LANDSIDE ACCESS MODERNIZATION PROGRAM

ITF-W_A Interim Ground Access (IGA) **Project # DA-5305A**

Package Transmitted For	Delivered Via	Tracking Number
CO-0008-PDG FULLY EXECUTED ITF-W A Interim Ground Access (IGA) Change Order #08 for CPCN No# 1007A, 1004A, 1003A, and 1011A 2019-06-21		CO-0008-PDG FULLY EXCUTED

CHANGE ORDER NO. 0008

Light
Electrical
Box # 1 .
Damage
BROOKS

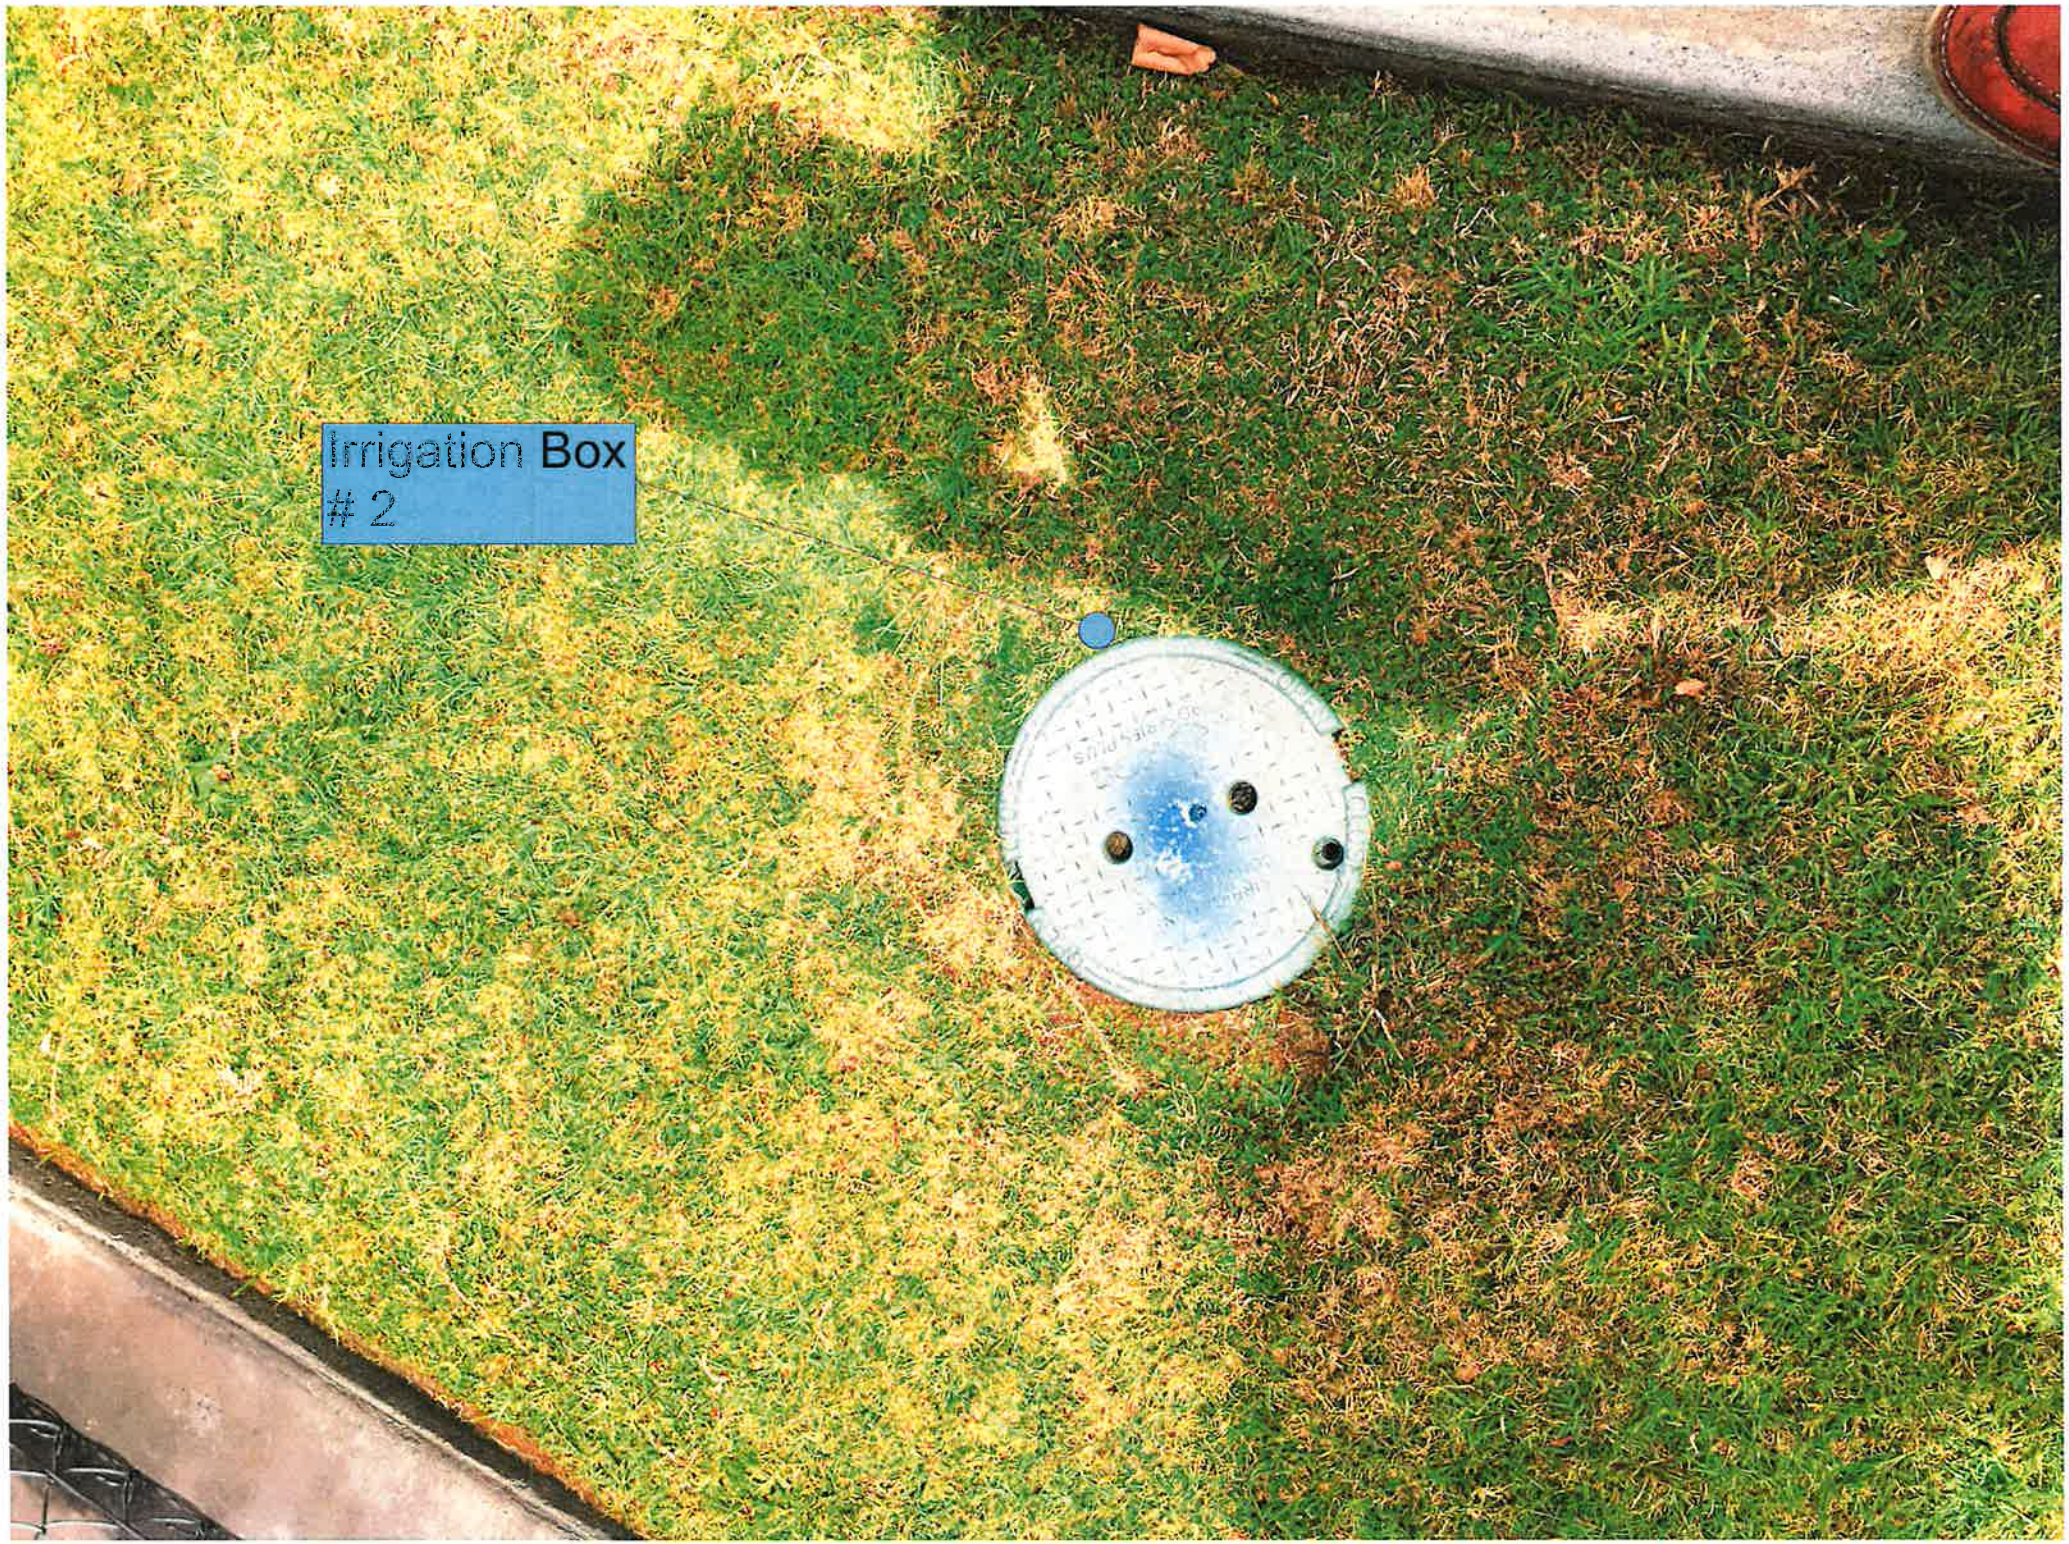
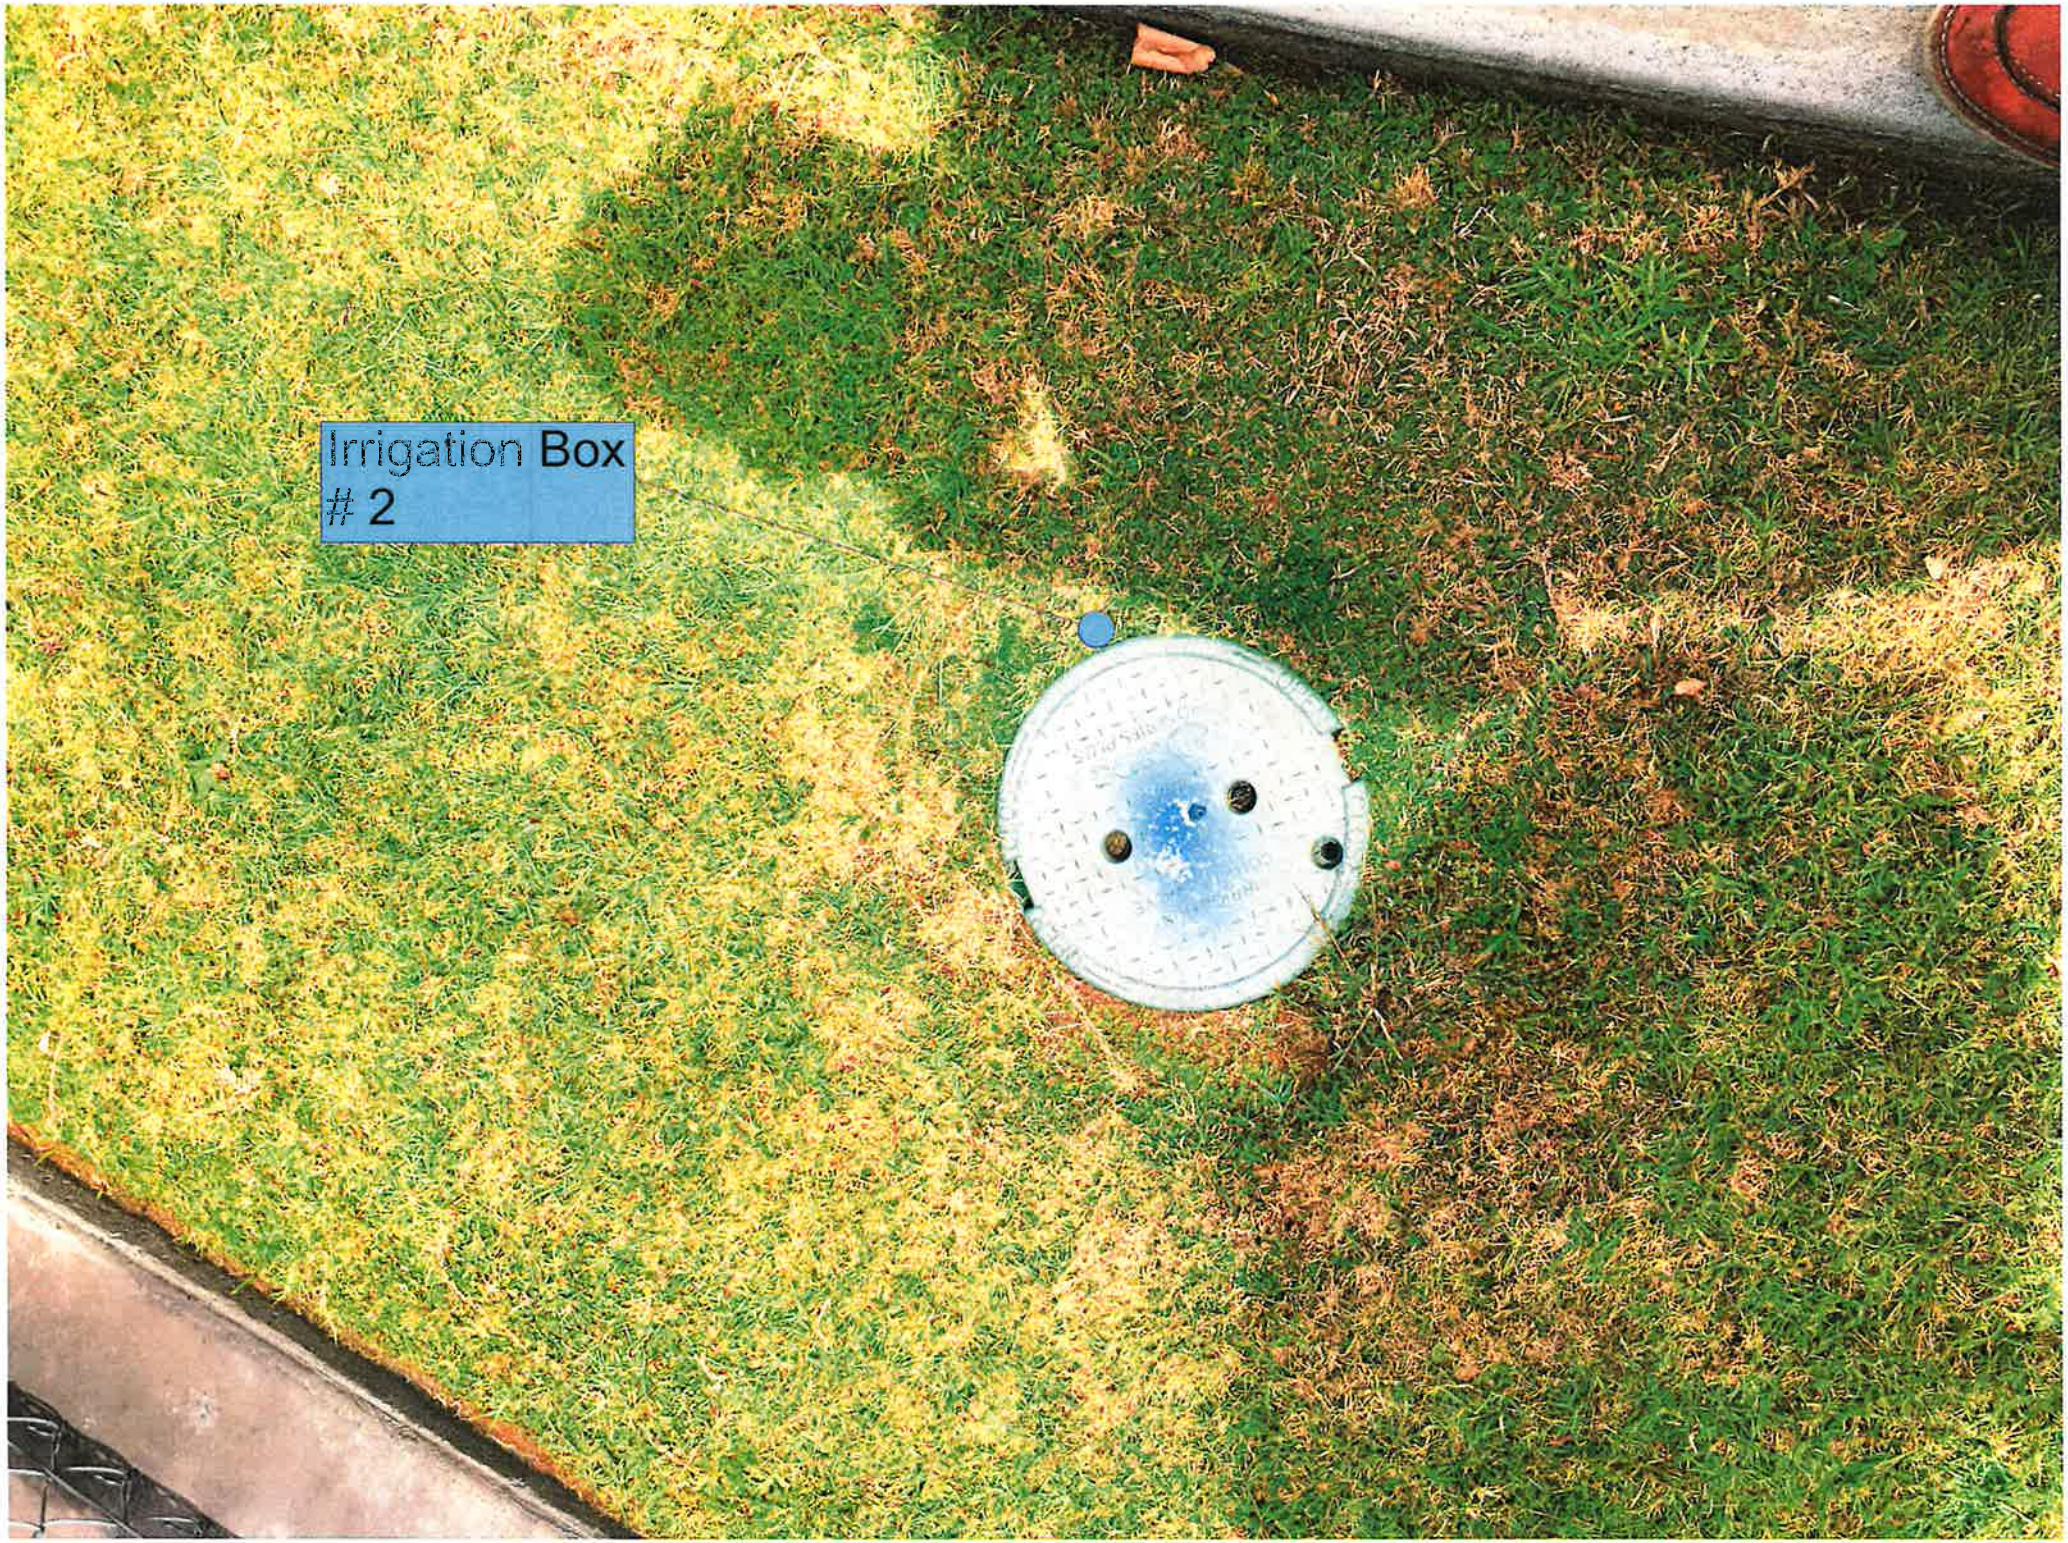
Light Electrical
Box # 2 .
Damage

Contractor shall provide labor, materials and equipment required to replace the existing damaged utility boxes as directed in the response to RFI-0010. CD-0007 was issued on 04/30/2019 directing Swinerton to proceed with removing the existing utility boxes shown on drawing C101 and replace with new boxes. Boxes outside of the construction limit should be protect in place. The Costs associated with T&M authorization shall fully comply with General Conditions by (T&M).
